SEBAGO LAKE STATE PARK
PARK HEADQUARTERS BUILDING REBUILD
APRIL 30, 2015

ADDENDUM#1 5-25-2015

SEBAGO LAKE STATE PARK HEADQUARTERS BUILDING REBUILD ADDENDUM # 1

SK - 0.01

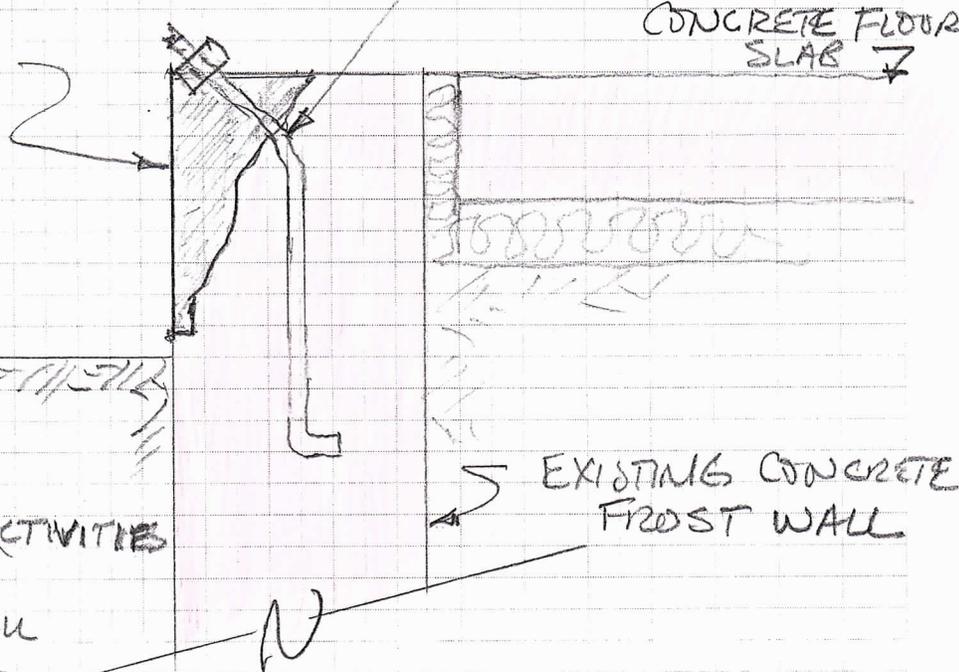
SHEET S-100 FOUNDATION PLAN – Add note 9 under foundation notes as follows: "Room 20 has a 4" slab over 2" of rigid insulation. All other spaces to have 3" slab over 3" insulation". Add note 7 under Alternate 2 as follows: "New concrete foundation walls and footing under Alternate 2 to be unreinforced." Add attached detail labeled SK-0.01 to this sheet. This detail describes required repairs to the existing foundation around the existing anchor bolts.

BEFORE DEMOLITION ACTIVITIES
DAMAGED TOP OF
EXIST CONCRETE WALL
CUT EXIST ANCHOR BOLTS
FLUSH WITH CONCRETE.
REPAIR DAMAGED CONCRETE
AS SHOWN.
